BEFORE THE
UNITED STATES NUCLEAR REGULATORY COMMISSION

PROPOSED AMENDMENT NO. 57

SUSQUEHANNA STEAM ELECTRIC STATION
UNIT NO. 1

This amendment contains a revision to the Susquehanna SES Unit 1 Technical Specifications.

CHANNEL A 125V DC
SINGLE LINE DIAGRAM
(TYPICAL OF 4 CHANNELS)

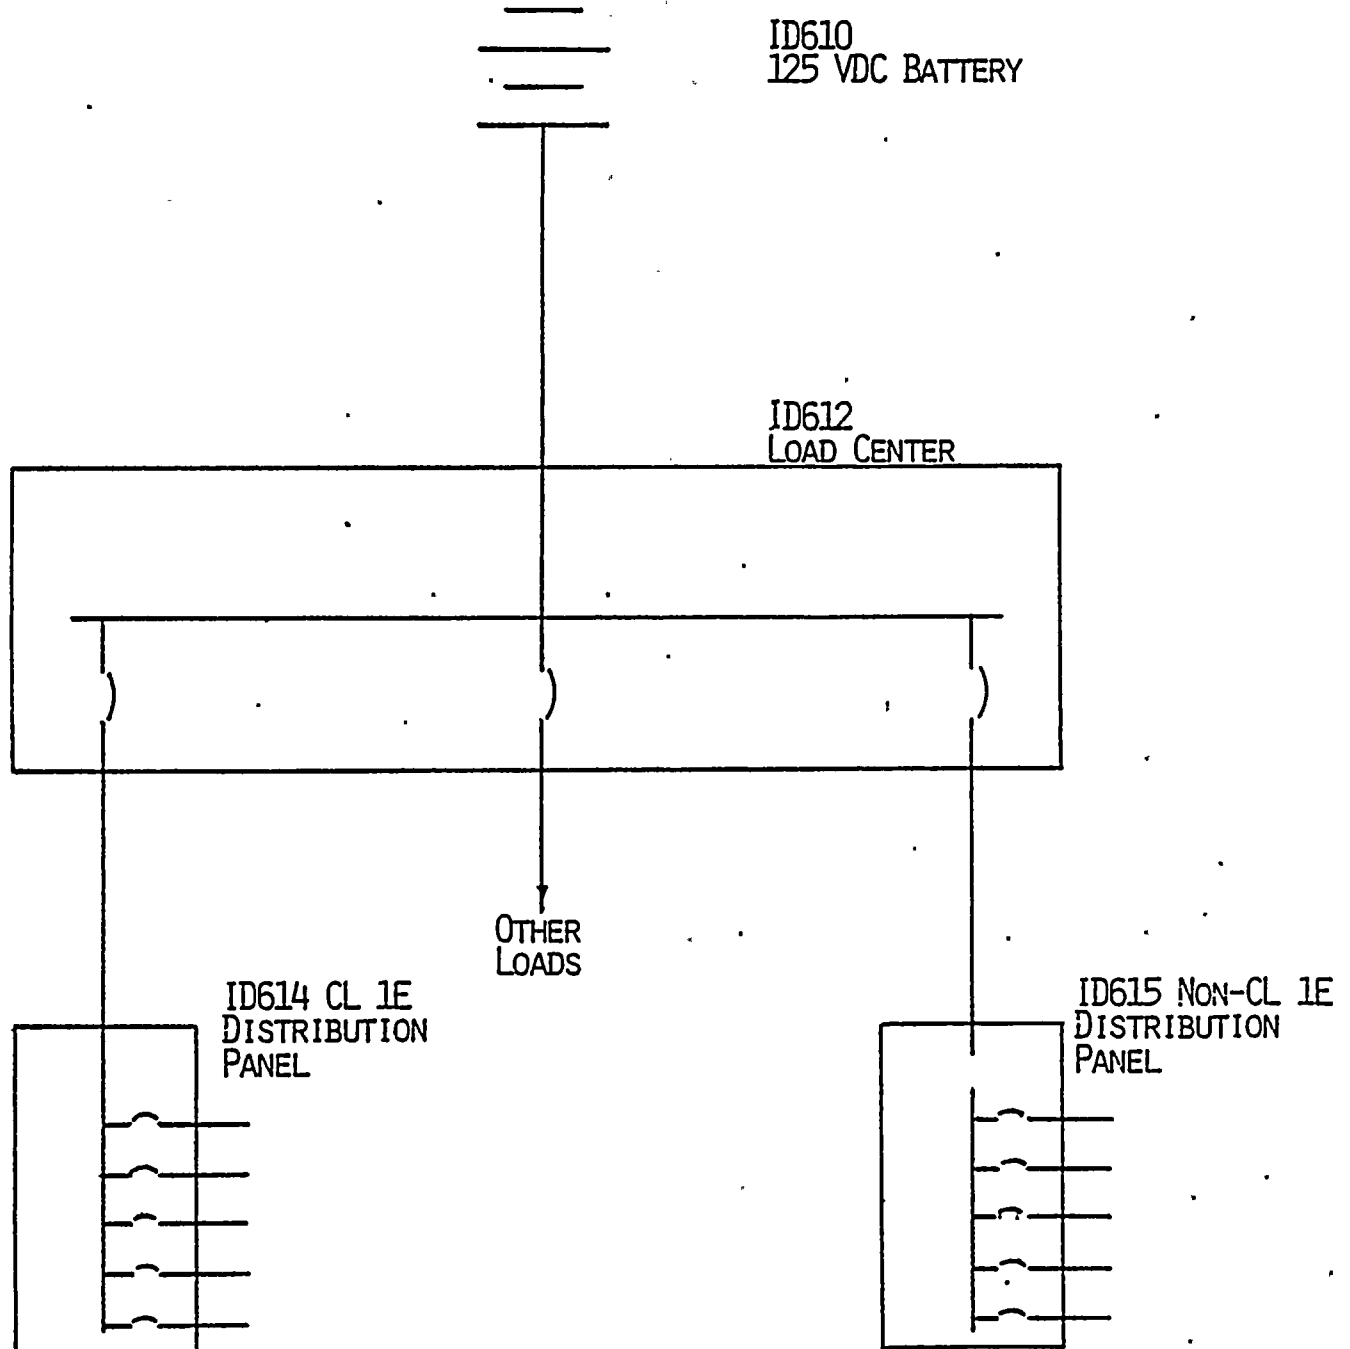
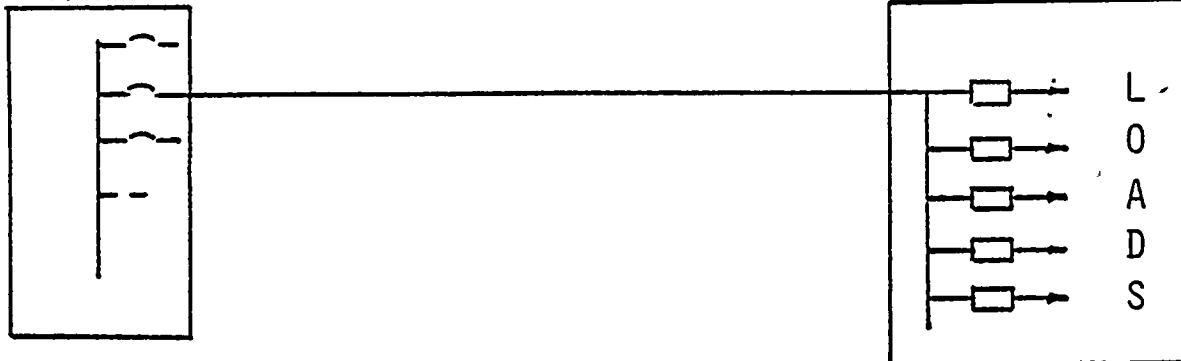
EXISTING CONFIGURATION

ID614
DISTRIBUTION
PANEL

COMMON LOAD:
CONTROL PANEL,
4KV SWGR, ETC.

NEW CONFIGURATION

ID614
DISTRIBUTION
PANEL

NEW MANUAL
TRANSFER
SWITCH

COMMON
LOAD

2D614
DISTRIBUTION
PANEL
